Technical product information

Topic	New Continental GT - Ski hatch difficult to latch/unlatch
Market area	Bentley: worldwide (2WBE)
Brand	Bentley
Transaction No.	2052208/6
Level	EH
Status	Released for publishing
Release date	07-Nov-2022

Figure 2

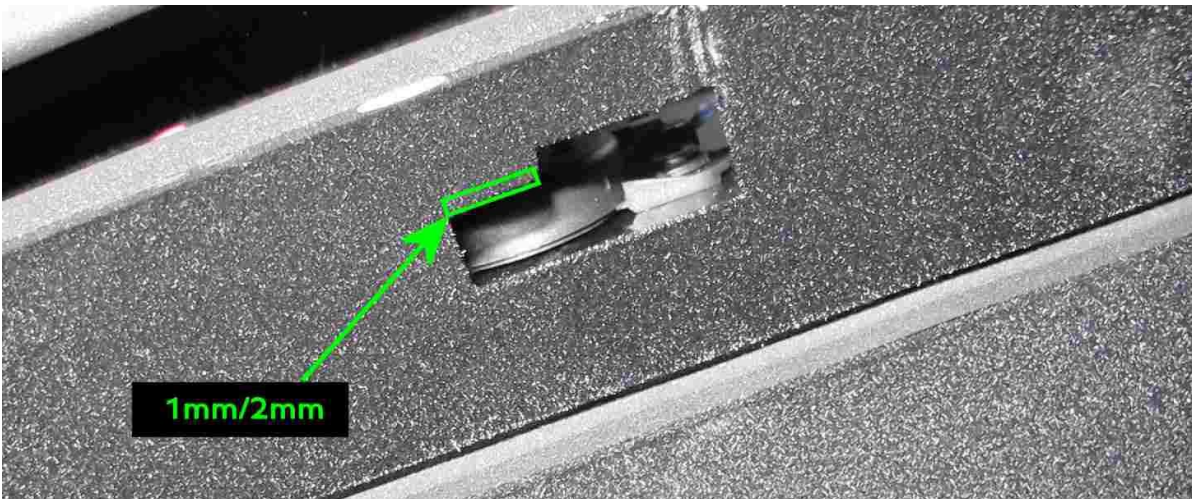
Due to tight tolerances the ski hatch mechanism fouls the upper ski hatch trim when closed/locked.

The close proximity of the mechanism in relation to the hatch trim when closed/locked can create difficulty in opening/unlocking the hatch

- Referring to Figure 2, Using a suitable tool initially remove up to 1mm from the trim and retest
- In the event the hatch does not close remove a further 1mm from the lock trim and retest
